Consultant: dar making progress together	THIRD SAUDI EXPANSION OF THE HOLY MOSQUE & SURROUNDING AREAS	Contractor: مجموعة بن لادن السعودية SAUDI BINLADIN GROUP Haramain Division قطاع الحرمين الشريفين
Project Ref:1150		Issue Date: 24-NOV-2025

WORK INSPECTION REQUEST (WIR)	WIR Reference No.	Rev.
	SHE-CUC-EL-10426	00

Project Name: ....Makkah Haram Shamiya Expansion CUC...

Pulling fiber Optic cable (12C Fiber Optic Cable SM 9/ 125 OS2, Loose Tube, Glass Armour In-door/Outdoor LSOH Sheath) from 01-RTU-EC-01 to 01-RTU-M3-04 in Chiller building Area as per detail and highlighted drawings.

Drawing No.
CUC-SD-SA-C02-M1-1420

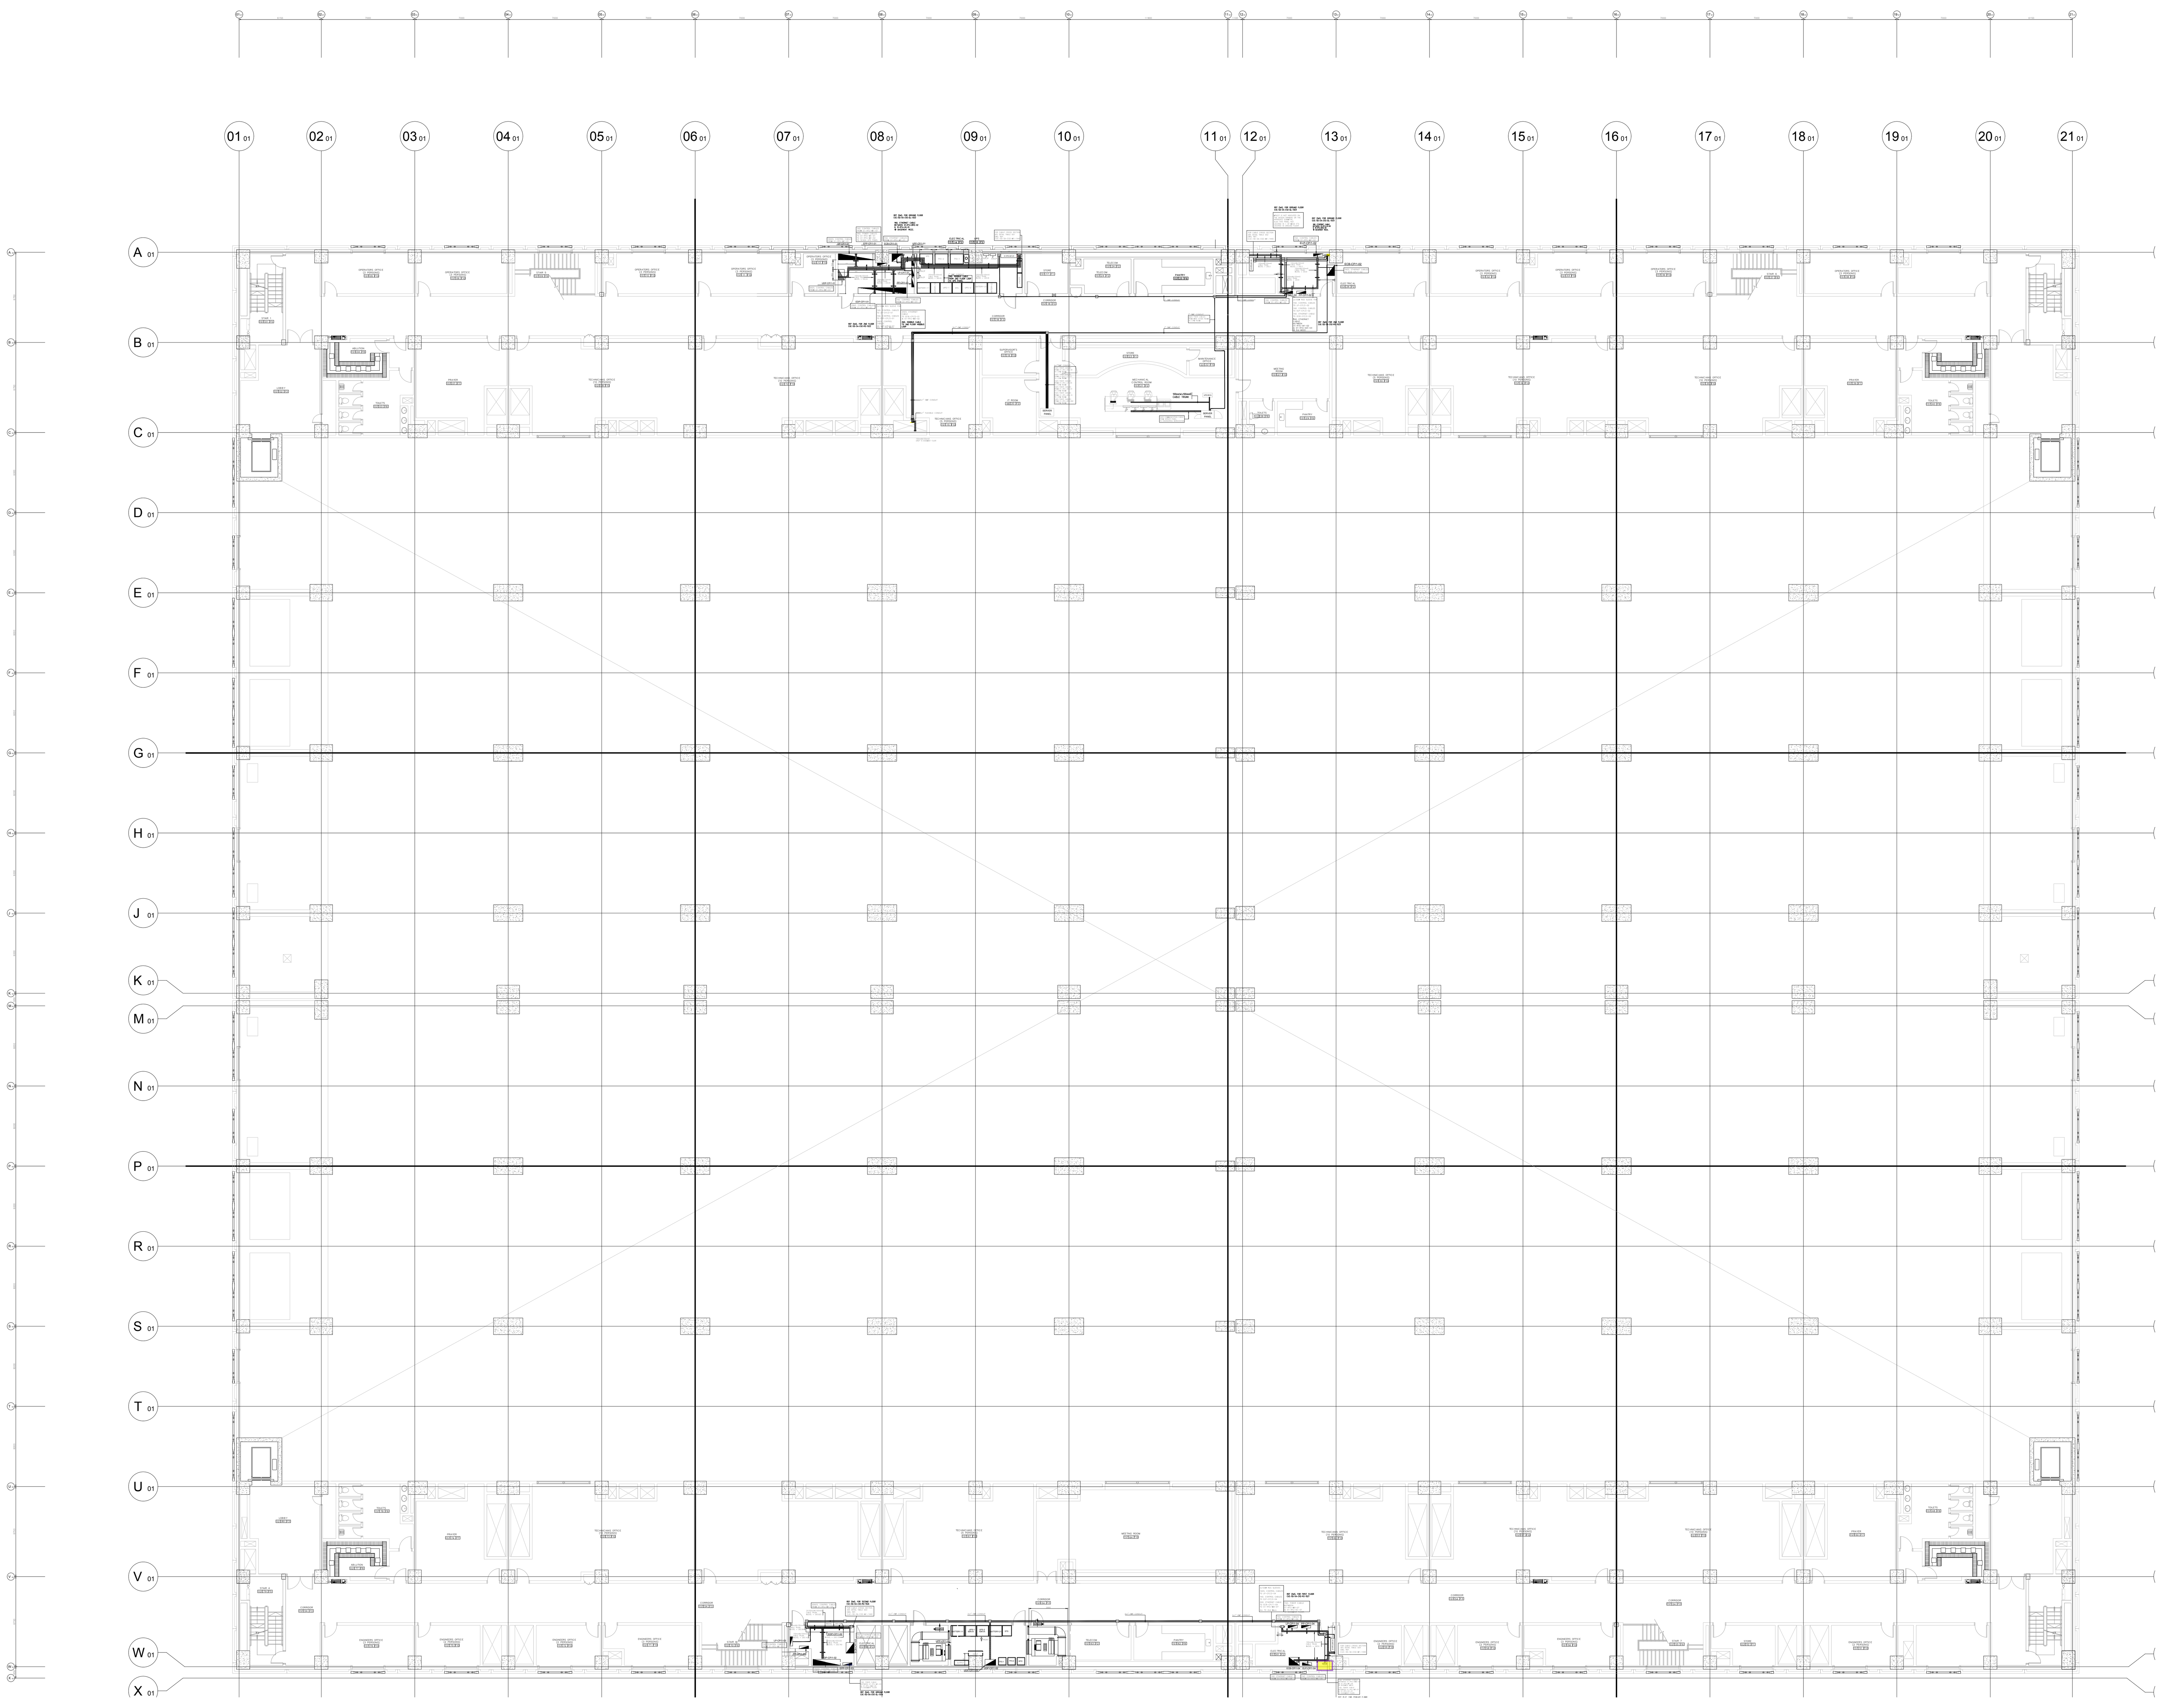
Elcc (Repeated).
This part is still not submitted as per our previous revision comment; only part-2 is submitted under SD# CUC-SD-SA-C02-M1-1422-R04.

LC Comments: Code "B"
** Refer to previous Comment on previous Rev..
13/5/2018. Mtz

Drawing No.
CUC-SD-MS-M02-CT-3500-R04

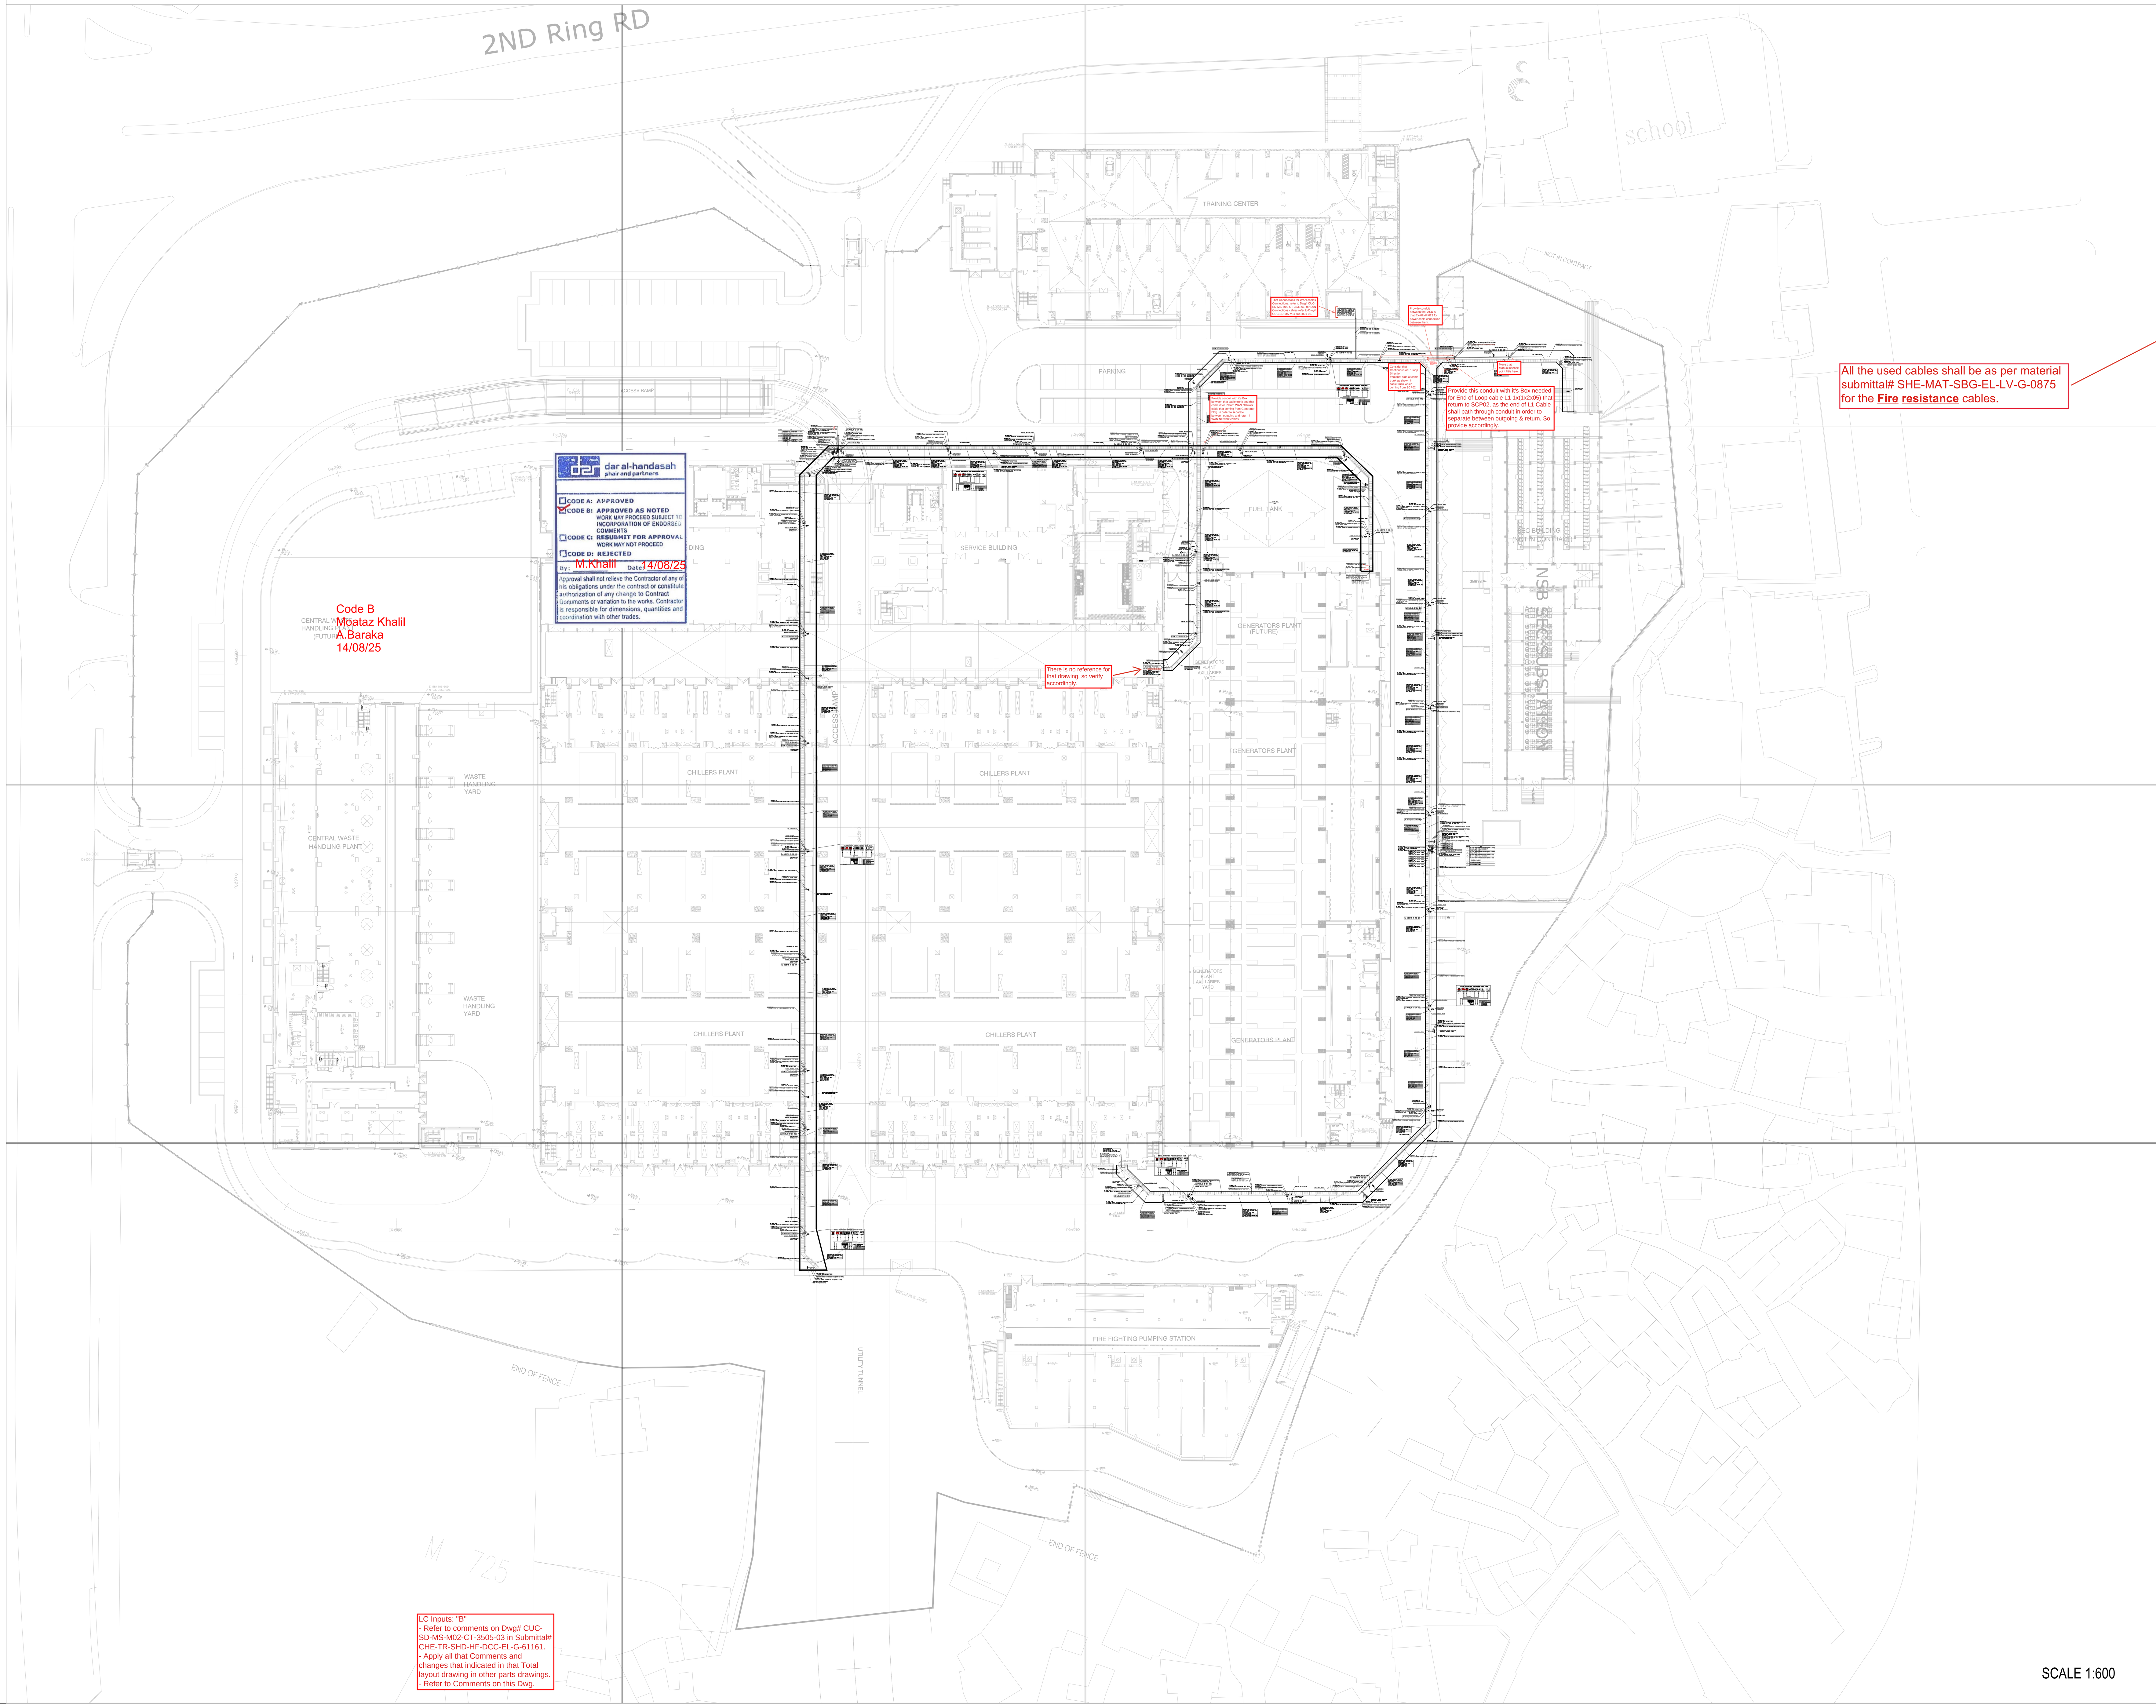
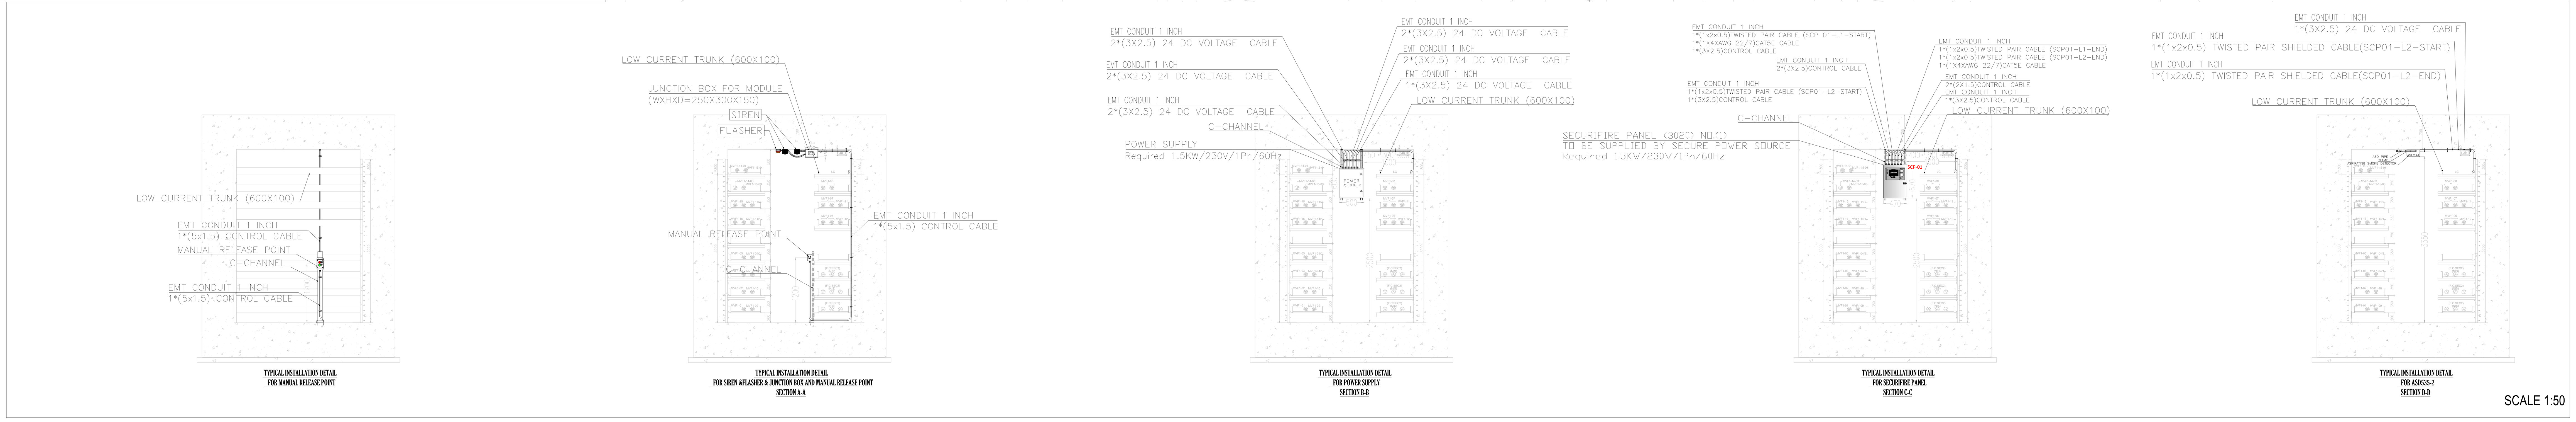
comments	reply
The below clouded area of culvert is not covered by alarms devices, so Contractor shall study to Move little that first & second stage alarms devices in that location to cover the below clouded area of culvert.	noted and modified
No reference for using that panel and power supply and it's locations, so verify and provide the reference accordingly.	securifire panels and power supplies will be reflected in power shopdrawings after approval of HI-fog system drawings
Contractor shall consider Filling ratio for each conduit shall not Exceed 40%, so verify and update accordingly.	please refer to filling ratio table
No reference to indicate that cable trunk, Moreover there is no any reference indicate that cable trunk is an Existing cable trunk.	this cable trunk existing in site and BinLadin confirmed with Dar site to install cables on it
Missing size for that cable trunk and it's invert level, Moreover provide filling ratio for that cable trunk.	noted and modified please refer to filling ratio table

Outgoing and return for each cable shall not share the same conduit, contractor revise accordingly. (Typical for all other cables).	noted and modified according to NFPA 72
Clarify if There are any other cables from another system in that Existing cable trunk, Moreover it's recommended to use conduits instead of cable trunk for that cables raceways.	There are no cables on cable trunk and BinLadin confirmed with Dar site to install cables on it
For what using that cable (2x1.5) control cable. (Typical for all), clarify.	noted and modified refer to Cables functions table
Directions, raceways & connections of all cables for devices in this layout are different than indicated in Riser diagram, so verify and update riser diagram accordingly to be matched with it's layouts drawings.	noted
No reference for using that Valve box, provide accordingly, Moreover Missing the cables connections that connect to Module (BX-O2I4) and also to panel. (Typical for all). Missing indication about Valve Box and it's cable connections in Riser diagram.	please refer to detail A showing the valve box connections

As two sides right & left of culvert have a cable trunks, so how ASD will be installed, so Provide section detail for ASD along culvert and it's connections.	noted and modified typical installation details for ASD
There is no indication for that cable in legend. (Typical for all).	(4x0.75) control cable it is built in cable with limit switch of flush valve and ball valve
It's not accepted to indicate only 1 line of Conduit in layout, Although the Indicated Conduits are 2, So update to add 2 lines of conduits not 1 in layout accordingly.	noted and modified
Devices locations to match with Approved shop drawings for Hi-Fog system.	noted and modified
All the indicated cables on drawings are not traceable, Contractor to define each cable shall be connected (from which device to which device).	please refer to riser diagram
Contractor shall provide Filling ratio calculation in a table, assure to not exceed 40%.	noted and modified please refer to filling ratio table

Indicate each cable drawn from the power supply shall be connected to which device.	please refer to riser diagram
The Approved Manufacturer Stamp is required to ensure proper system connectivity.	Please note that the HI-FOG designer and reviewer by Deutschland technology limited as shown in legend
Function for each running cable to be indicated (indicate each cable shall be connected to which device).	noted and modified refer to Cables functions table
Loops cables to be identified with indicating where is loop cable going.	please refer to riser diagram
Final Approval for Materials is upon Material Approval.	noted
move little first & seond stage alarms in center of culvert.	noted and modified
Provide section detail for that Manual release device inside culvert.	noted and modified typical installation details for manual release point
it's not accepted that a cross connection, so update the connection like that.	noted and modified

This 4 or 2 Conduits, clarify.	it is 4 conduits please refer to typical installation detail for power supply
Provide the height FFL from bottom of power supply.	noted and modified
Provide the height FFL from bottom panel.	noted and modified
Missing Panel in legend.	noted and modified
Provide signatures from other trades in Coordination table.	noted and modified
Directions, raceways & connections of all cables of devices in layout are different than indicated in that Riser diagram, so verify and update riser diagram accordingly to be matched with it's layouts drawings.	noted and modified
As per below comments, contractor shall verify and update No.'s of Network cables that run in Conduits and cable trunk that run through that area.	noted and modified
Consider that Loop cable direction L2 to be like that through cable trunk which coming from SCP02.	noted and modified
Differentiate and clarify between network cables going to Panels in that Culvert and the other network cables going to panels in other Buildings.	noted and modified

Provide this conduit with its Box needed for End of Loop cable L1 that return to SCP02, as the end of L1 Cable shall path through conduits, So provide accordingly.	noted and modified
The path for that return Network cable is not matching and different than indicated in Topology diagram drawing# CUC-SD-MS-M02-CT-3533-00, as that return network cable run from Panel# SCP-03 panel that located inside room# GR-022-F3 room and connect to Panel# SCP-01 in GR-009-F3 room through an internal path inside same Generator Building not through culvert as indicated in Shop drawings# UGE-SD-ER-E02-GL-3212 & UGE-SD-ER-E02-GL-3214, so verify and update accordingly.	noted and modified
There is no reference for that drawing, so verify accordingly.	noted
why there are two Network cables connections between panel# SCP-02 located in 1st-61-F2 room in Chiller plant and panel#SCP-01 in GR-009-F3 room in Generator Building which is different than indicated in Topology diagram drawing# CUC-SD-MS-M02-CT-3533 that there is only one network cable connect between them and the other network cable for SCP-02 that located in 1st-61-F2 room in chiller plant connect to other panel in other Building, so verify and update accordingly.	noted and modified

Provide signatures from other trades in Coordination table. (Repeated comment).	noted
